AEBS-08 – Industry Input

AEB IWG 08 – Industry Input

Maximum required system performance

(GRVA-02-22e V. and VII. Proposal)

5.2.1.4. Speed reduction by braking demand

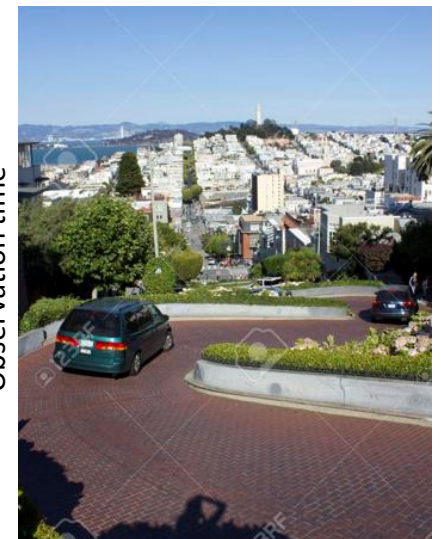
Does this mean whenever the 5 conditions are fulfilled, the system shall deliver maximum performance?

It is recognised that the performances required in this table may not be fully achieved in **other conditions than those listed above**. However, the system shall not deactivate or drastically change the control strategy in these other conditions. This shall be demonstrated in accordance with Annex 3 of this Regulation.

A lot of conditions remain undefined in the requirements section, yet it requires maximum performance!

When the system is activated, the AEBS shall be able to achieve the maximum relative impact speed as shown in the ~~following~~ table ~~below~~.

It is recognised that the performances required in this table may not be fully achieved in ~~case the conditions deviate from those described in the test procedure in paragraph 6 or in case other conditions [not mentioned in this regulation] affect the performance of the system (e.g. trailer hitched to the vehicle)~~ ~~other conditions than those listed above~~.

However, the system shall not deactivate or ~~drastically~~ ~~unreasonably~~ change the control strategy in these other conditions. This shall be demonstrated in accordance with Annex 3 of this Regulation.

Maximum speed reduction above the avoidance speed for Car 2 Ped Step 2
(GRVA-02-22e XIII. Proposal)

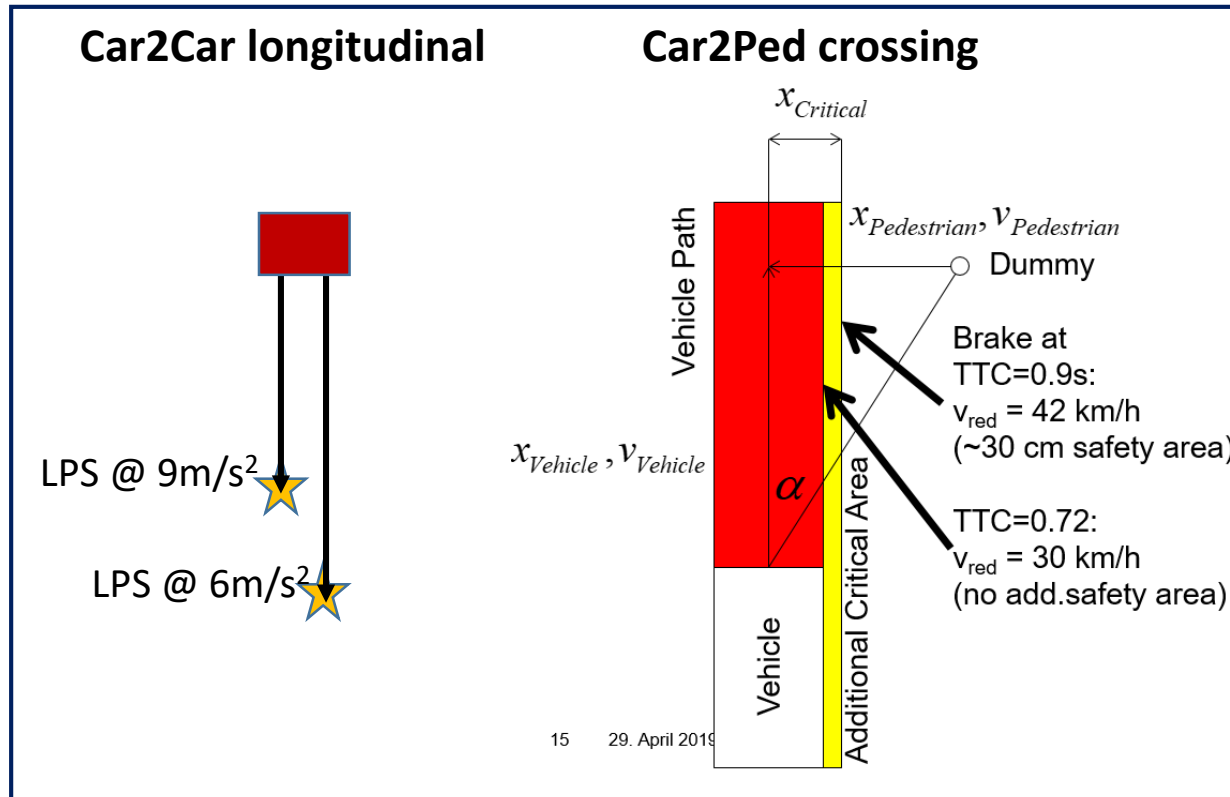
- 2. The assumed deceleration has a much higher influence on the Car2Ped scenario, because the LastPointToSteer isn't relevant.

- Brake intervention starts always at the same speed-dependent distance to the point of impact.
- If only a deceleration of $6,43\text{m/s}^2$ (5 m/s^2) was achievable, this would result in lower possible speed reduction, as suggested by Industry.
